Technical Service Bulletin

SQUEAK NOISE WHEN OPENING AND/OR CLOSING LIFTGATE AFTER PERFORMING RECALL 9916H

Bulletin No.: 09-030/19

Mazda5 (USA ONLY):

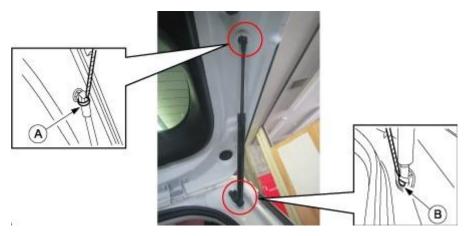
1. Using a small screwdriver, remove the stay damper bands from the liftgate side (A) and from the vehicle side (B) as shown below.
